BGA TECHNICAL COMMITTEE

TNS 7/8/85

PART 1 Airworthiness "Aggro" (Please add to the 1985 Green Pages)

DISABLED PILOT AIRBRAKE LOCK

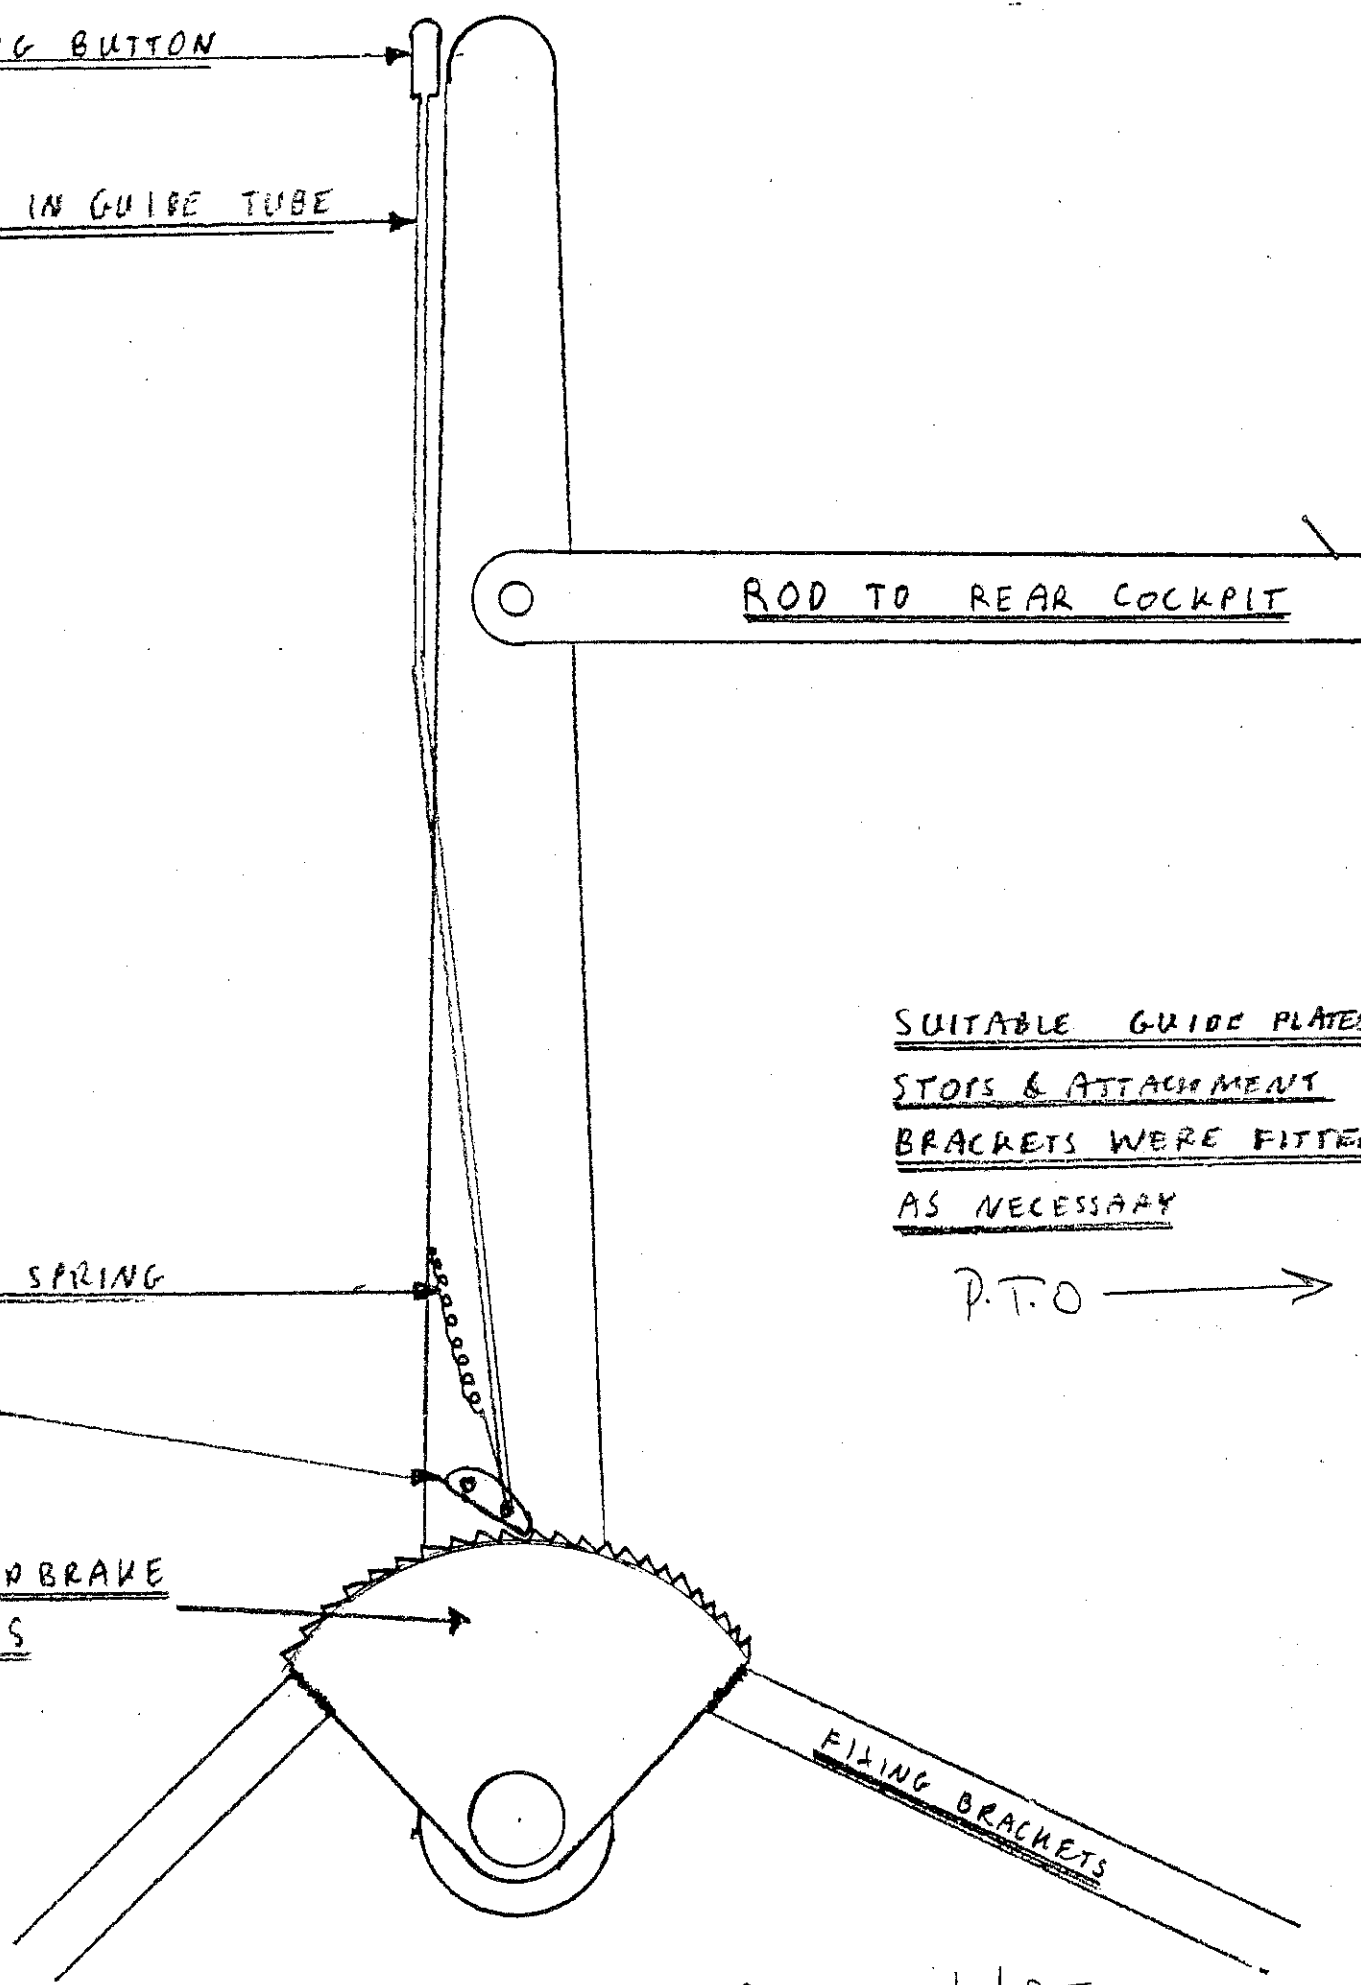
- 2.1 Disabled Person Airbrake Lock (Ka 2). The attached sketch from Tim MacFadyen, Cotswold GC, could apply to other types.
- 2.2 TUGS - Full Flow Oil Filters will prevent debris contaminating bearings and causing catastrophic damage. Lycoming Service Instruction 1319B refers. Where space is limited, full-flow oil filters may be installed in pipelines to oil cooler installations. Consult your maintenance organisation.

To enable one to lock the airbrakes in any position, so as to be able to use the hand rudder while landing, a motor car type "fly off handbrake" mechanism was fitted to the front cockpit airbrake lever.

When the button is pushed on the top of the front airbrake lever a paw engages in a ratchet and prevents the brakes opening further. The "such open" force on the airbrakes holds the paw engaged until the lever is pushed forward, by either pilot, when a spring raises the paw and the brakes revert to normal operation.

The airbrake lever was lengthened and the cable release lever raised to make the use of these levers easier.
